California Department of Transportation

October 30, 2023

SCH #: 2023100309
GTS #: 04-NAP-2023-00331
GTS ID: 31115
Co/Rt/Pm: Napa/29/30.46

Re: Vineyard 29 Winery Major Modification #P20-00062-MOD – Initial Study/Negative Declaration (IS/ND)

A87A

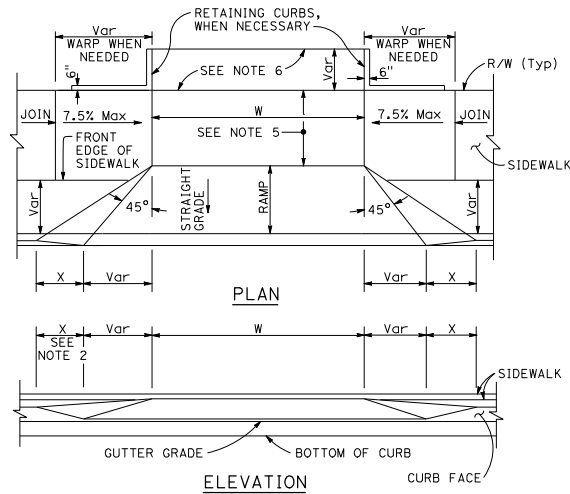
For the new driveway shown in Caltrans' ROW on sheet UP 3.0 and 3.1, the design shall conform to Caltrans Design Guidelines for Typical Rural Driveways ([link](#)) in Caltrans' Right-of-Way. Please also see the enclosed 2022 Standard Plan A87A for reference.
